**Upper Main Eel Temperature and Sediment TMDLs
Comment Responsiveness Summary
December 28, 2004**

2004 Pool/riffle above Tomki

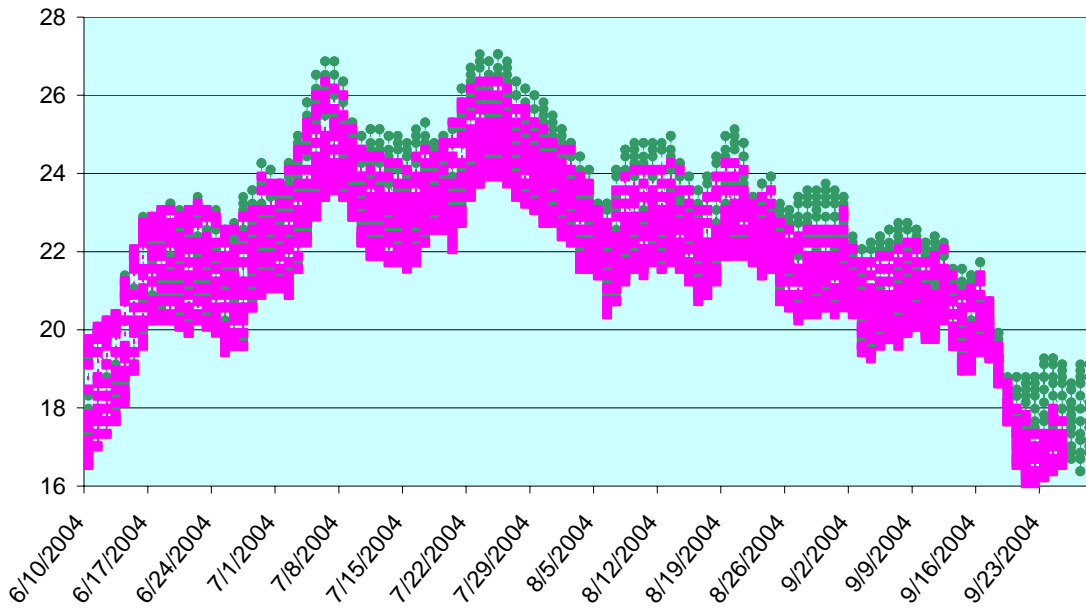
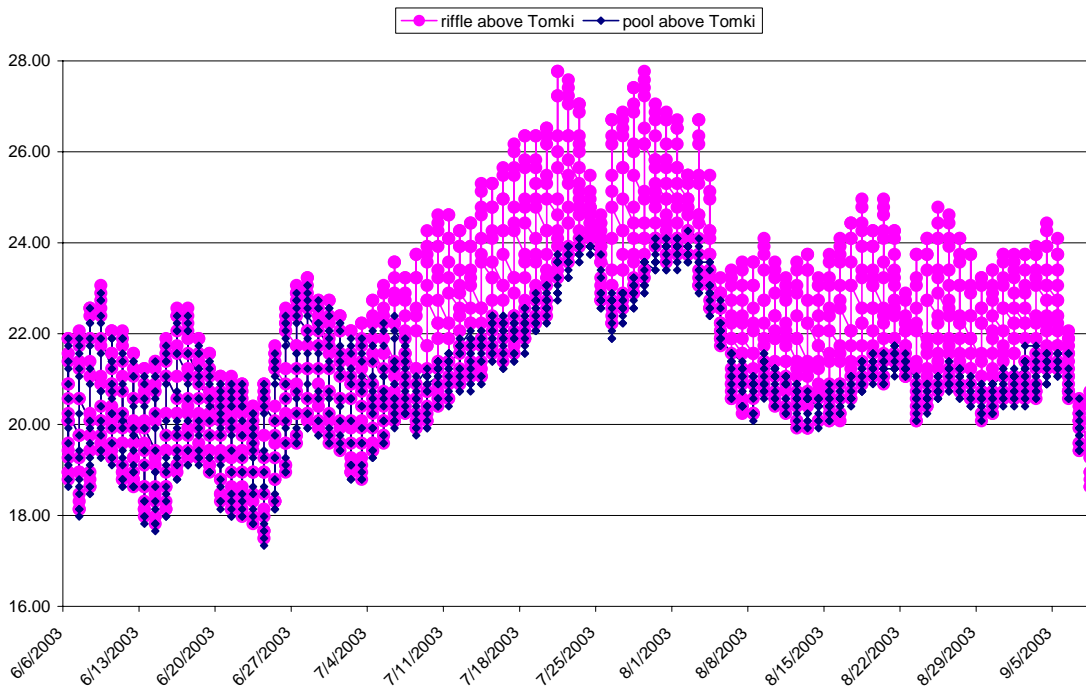
Comment 2-15: "Explain how this model handles temperature stratification in deep pools and state model assumptions and the inherited limitations. Sensitivity tests should be conducted to determine important parameters in the context of the uncertainty relative to the modeling accuracy."

Response: The stream temperature model does not account for how increases in flow influence the temperature stratification in deep pools. The 2004 temperature monitoring data by DFG provides information on 2 pool riffle combinations near Tomki Creek and one pool/riffle combination near Emandal. One pool continued to stratify and one pool did not stratify. Specifically, data from 2004 for the pool riffle combination near Emandal indicates that this pool continues stratifying even under the 15 cfs summer flow. This same pool and riffle was also monitored in previous years. Graphs 1 – 3 illustrate the temperature patterns during 2002 - 2004. This data is preliminary, specifically, the temperatures at Van Arsdale were unusually warm (>24 °C) during much of July. Thus this information should be considered preliminary as it was an unusual pattern.

However, the 2004 data from one pool riffle complex near Tomki Creek indicate that the pool did not stratify. In the previous years the pool stratified for much of the summer. This lack of stratification could be due to the increased flow from the Potter Valley Project and is a loss in refugia for summering steelhead. During 2004 data from the other pool/riffle complex was not available due to the loss of one monitor. Results from future monitoring under increased flow conditions would assist in determining how widespread and common this loss of stratification is in the area. EPA recommends that PG&E increase the monitoring of pool riffle combinations over time. Monitoring of additional pool riffles is important given the mixed results of the 2004 data. Monitoring in this stretch of the Eel River needs to account for the yearly loss of monitors.
